From: Mess, Camie
Sent: Friday, March 22, 2019 3:59 PM
To: Whitney Hudson (whudson@bdarchitects.com)
Cc: Werner, Jeffrey B
Subject: RE: February BAR Action - 600 West Main Street

BAR 16-01-04
512-514, 600 West Main Street
Tax Parcel 290007000, 290006000, and 290008000
Heirloom West Main Development LLC, Owner/Applicant
Amendments to the COA

**CITY OF CHARLOTTESVILLE
BOARD OF ARCHITECTURAL REVIEW
STAFF REPORT**

Amendments to the COA

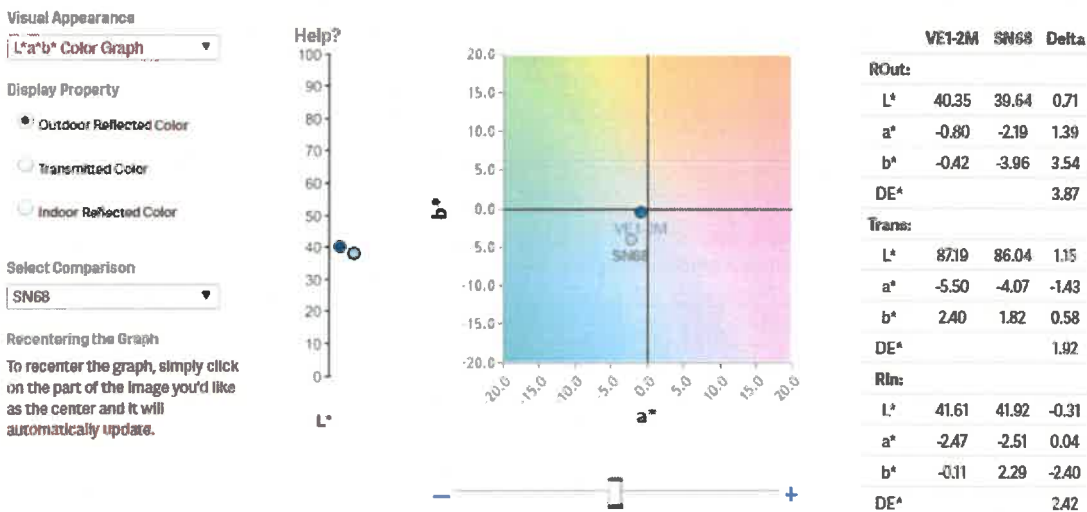
Guardian SN 68 is the comparable product to Viracon VE1-2M. The minor difference in visible light transmission is hardly noticeable by the human eye. The "Visible Light Transmission" is based a linear scale of the energy in the visible range transmitted through glass. In contrast, the "Lightness" (L^*) is a measure of the apparent amount of light transmitted as perceived by the human eye. This "eye response is not linear. The eye can adapt to the brightness of full sunlight all the way down to the very dim illuminance of starlight. In adapting to the extreme differences in light levels, it is less sensitive to very bright (such as high transmission Low-E products) levels, and more sensitive to light changes in very low light level conditions. In simple terms, the high light transmission variances are washed out when transmission level is high, but much more noticeable for very dark glass variances. As a result, it is misleading to use "Visible Light Transmission" for lightness differences for the eye. The L^* number gives a much better comparison for two different products.

The L^* difference shown above is only 1.15. The L^* , a^* , b^* system means that a number difference of 1.00 is only just barely noticeable to a trained eye under optimal conditions. For most people a color variation of 2.00 is more appropriate as just barely noticeable. For commercial architectural projects, a Delta E^* less than 4.5 is pretty much standard in the industry.
